Re: Compliance Stormwater Evaluation Inspection Concrete Supply Company – Spartanburg, South Carolina Permit SCR005527

# Water Compliance Inspection Report

Facility Name: Concrete Supply Co - Spartanburg SW-CSCSimuel-12/13/18

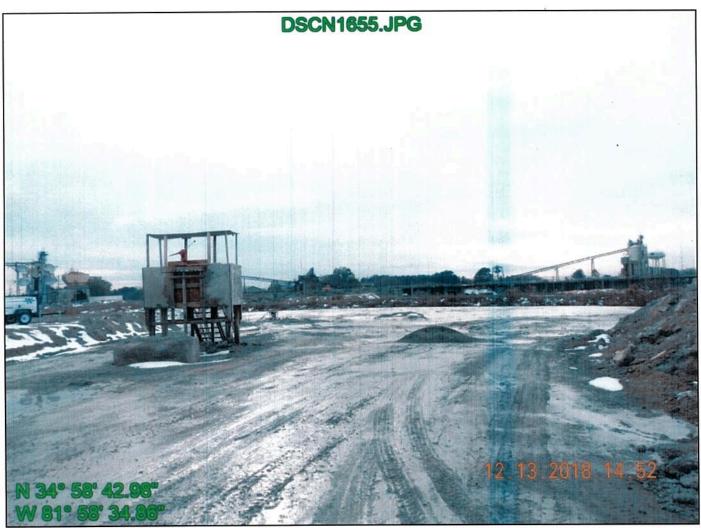
Diesel for loader and boiler. The drain plug for the secondary containment was off until inspectors pointed it out. The secondary containment was full of water with a sheen up to the drain level. There was no locking mechanism for the secondary containment drain.

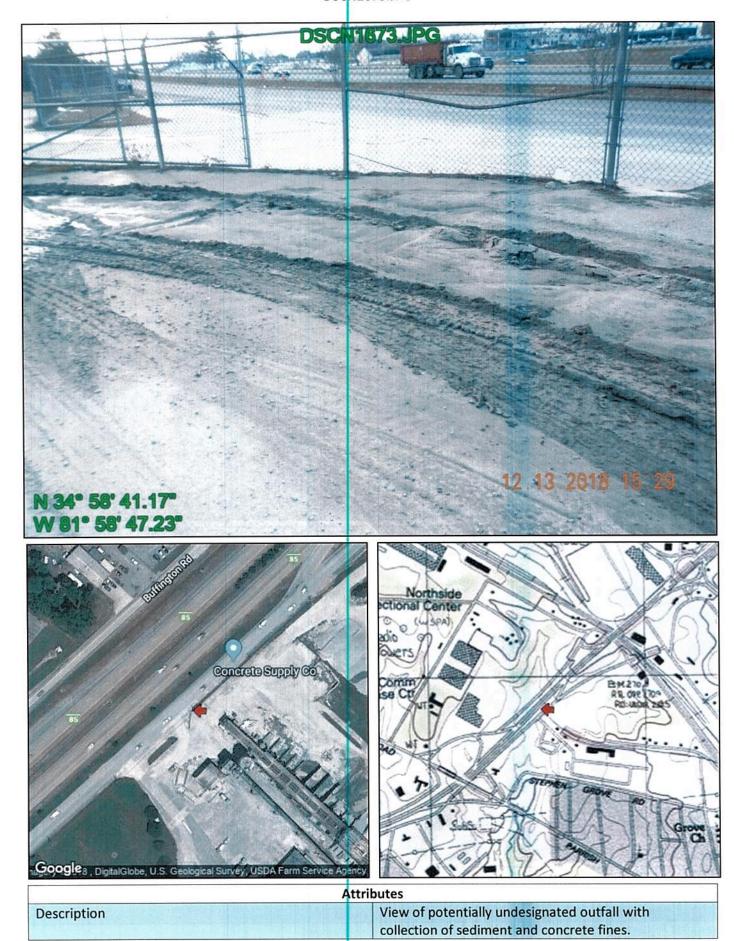
|             | Attributes   |
|-------------|--|
| Description | Figure 2 - Spartanburg Plant Site Map South from Concrete Supply Company's (CSC) Stormwater Pollution Prevention Plan (SWPPP) binder It illustrates Outfalls #1 and #2. In pen, CSCO was added and appears to illustrate a 3 <sup>rd</sup> outfall. Note that Archer Western's batch plant and piles are not located on this Site Map. The common washout pond (DSCN1655) is not on the Site Map as required by Permit Part 8.E.3.1. |

## Attributes DSCN1676.JPG

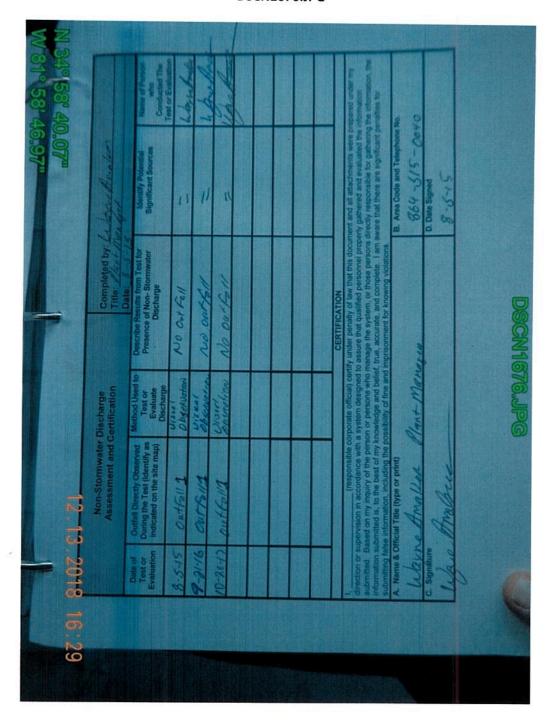
|             | Attributes   |
|-------------|--|
| Description | August 2015 Non-Stormwater Discharge Assessment Certification from CSC's SWPPP binder. It documents August 5, 2015 Outfall 1 visual observation, September 21, 2016 Outfall 1 visual observation and October 20, 2017 Outfall 1 visual observation. For all three dates, the "Presence of Non-Stormwater Discharge" is listed as "No Outfall" and no potential sources are identified. The certification statement was not signed for the 2016 or 2017 observations. |

#### DSCN1678.JPG

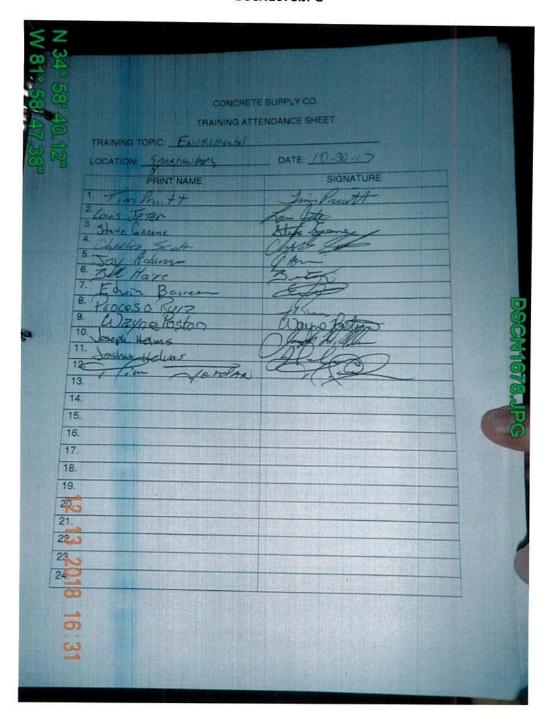
| Attributes  |   |  |  |  |
|-------------|---|--|--|--|
| Description | October 30, 2017 Training Attendance Sheet from CSC's SWPPP binder. Note that none of the names from the Archer Western contacts were present. Permit 2.1.2.9 requires employee training at least annually. |  |  |  |

## DSCN1682.JPG

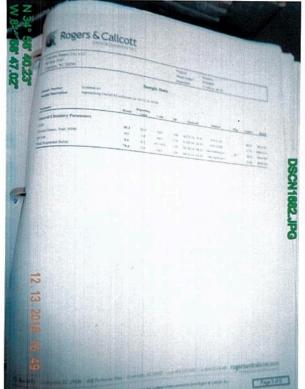
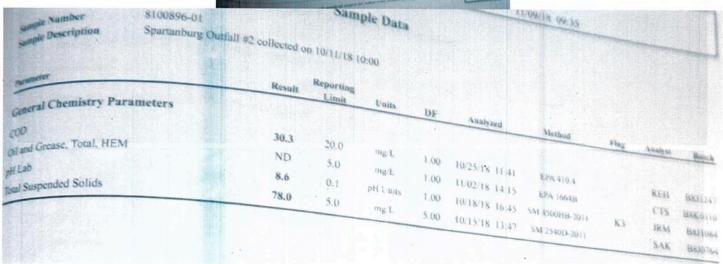
| Attributes  |  |
|-------------|--|
| Description | October 11, 2018 Outfall #2 sample in CSC's SWPPP binder. Total Suspended Solids were 78.0 mg/L, pH was 8.6, and COD was 30.3 mg/L. TSS of 78.0 mg/L. The TSS effluent limit in part 8.E.5 of the Permit is 50 mg/L for discharges from material storage piles at cement manufacturing facilities and 100 mg/L in part 8.E-1. No corrective action was observed in the SWPPF binder. |

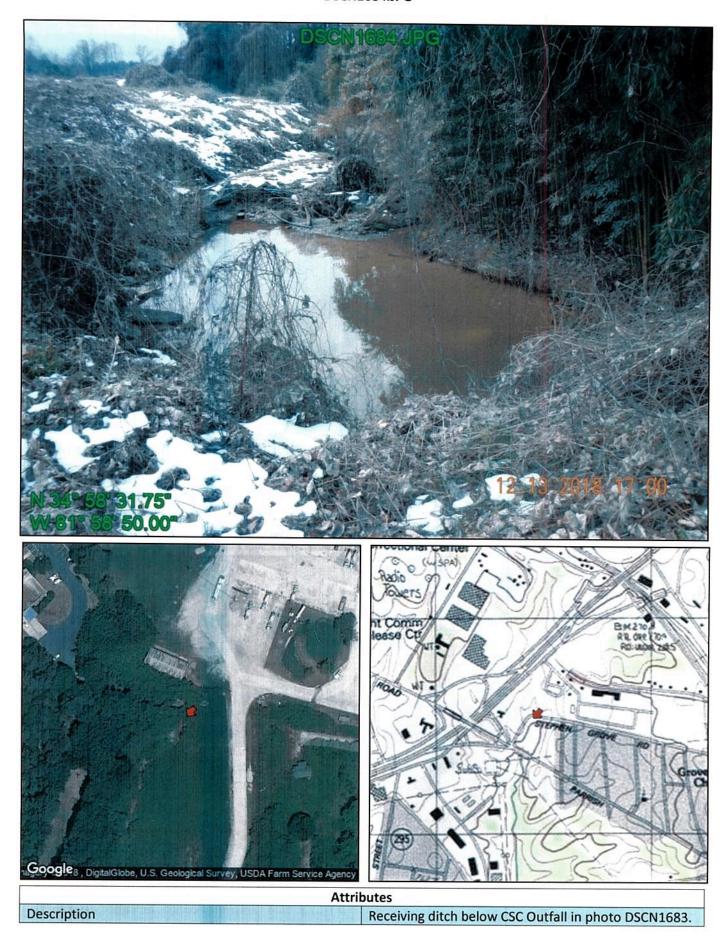
The Backup Plant Manager, Wayne Poston, described this as the Outfall for CSC. It is flowing. This matches the location designated as "CSCO" in the map shown in photo DSCN1674.

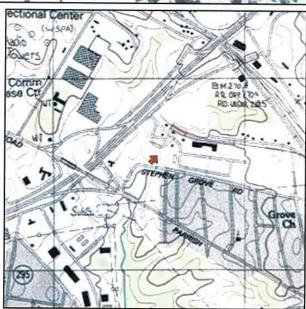
Two pipes with red circles added for easier viewing. One of these pipes appears to be the outfall from Metromont's pond (see photo DSCN1686). Note the turbid color.
